<input type="checkbox"/> Sidewalk Waiver (Form V2)	
SITE PLANS	<input type="checkbox"/> Waiver to IDO (Form V2)	APPEAL
<input type="checkbox"/> DRB Site Plan (Form P2)	<input type="checkbox"/> Waiver to DPM (Form V2)	<input type="checkbox"/> Decision of DRB (Form A)
BRIEF DESCRIPTION OF REQUEST		
No change to the site plan or footprint to the three structures. Modified glazing and shade structure to south and east elevations of Building D. Garage and operable windows are incorporated into the design of the future restaurant.

AVANYU NORTH - BUILDINGS D, E & F

AVANYU NORTH - BUILDING D

Re: Request for a Minor Amendment to the approved Site Development Plan for Building Permit for the proposed new construction at 2500 12th Street NW

A1 WEST
1/8" = 1'-0"

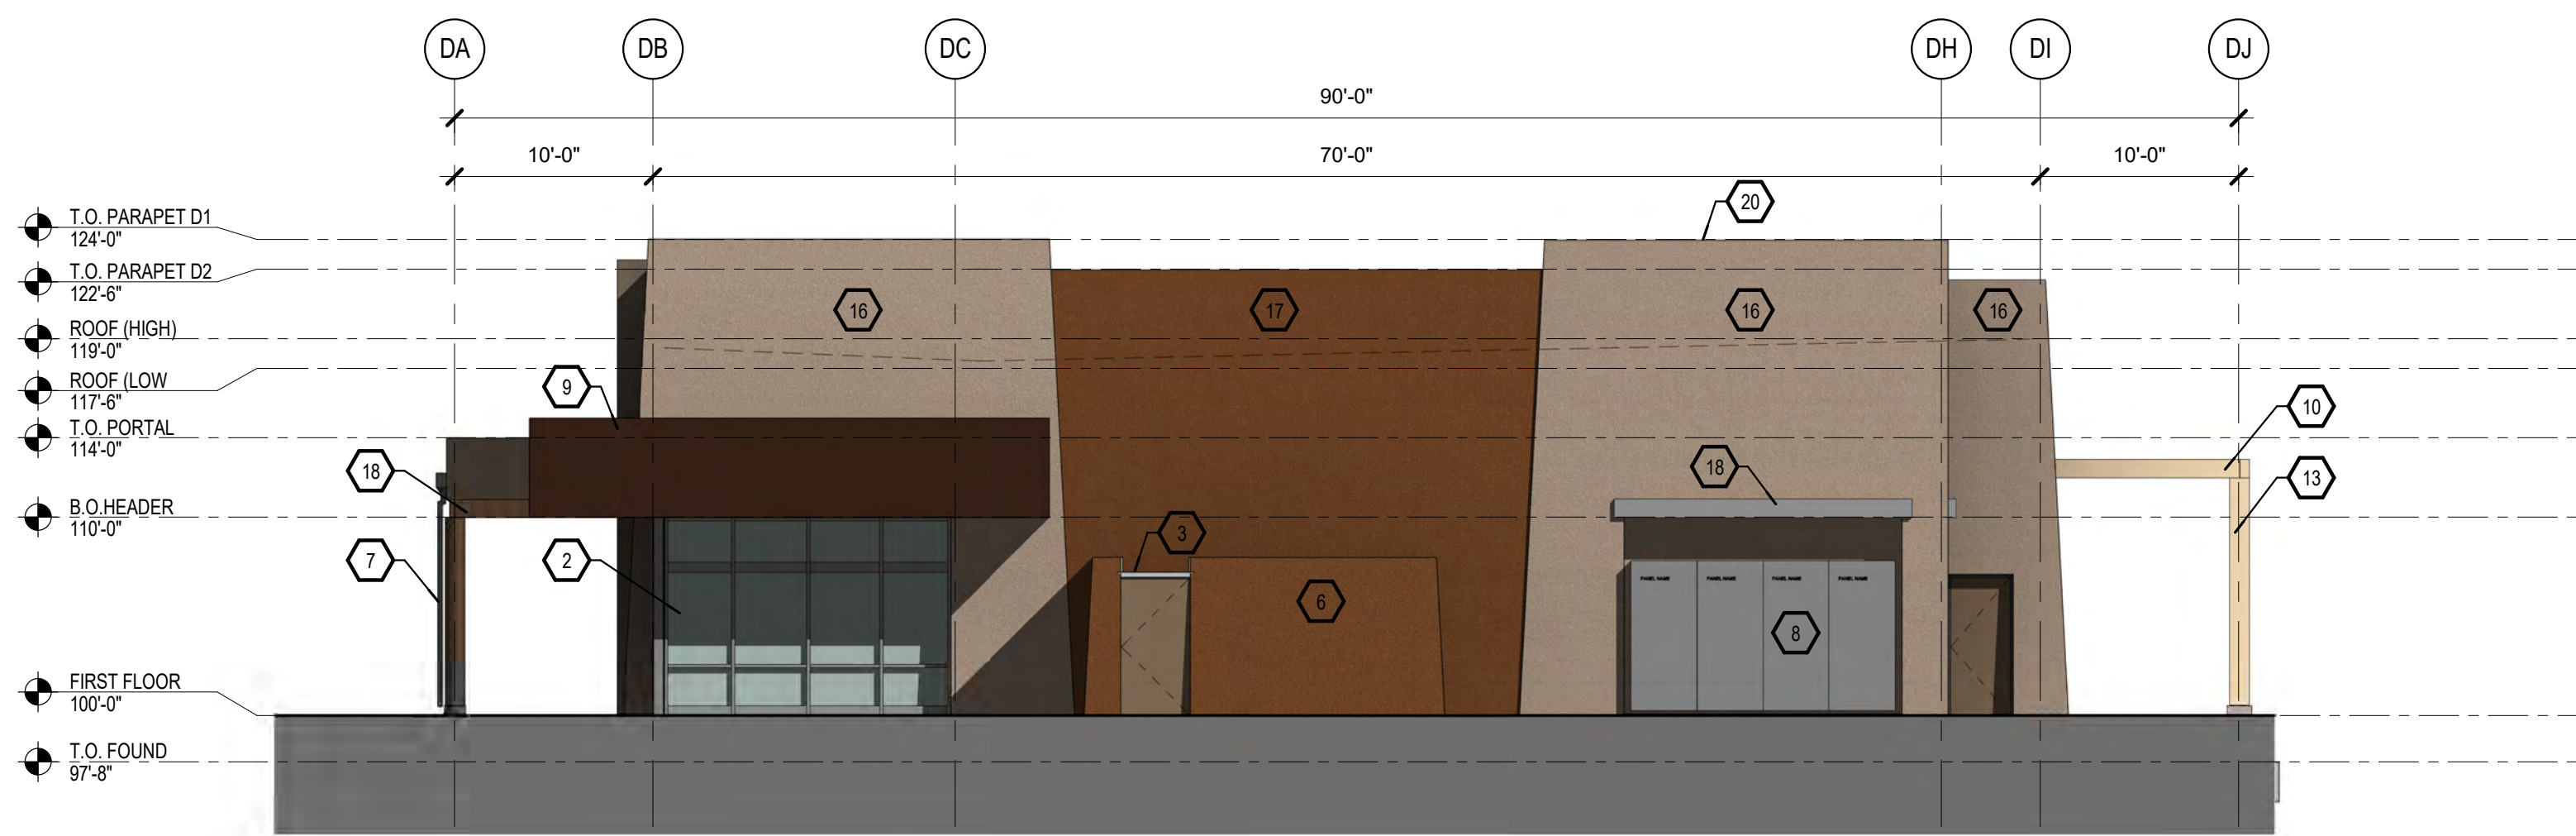
- 18. WOOD BEAM
- 19. ROOF DRAIN AND OVERFLOW AT PORTAL - INSTALL SPLASH BLOCK BELOW.
- 20. PAINTED METAL COPING.
- 21. ROOF SLOPE
- 22. OPERABLE GLAZING / ROLL UP - GARAGE DOOR TYPE
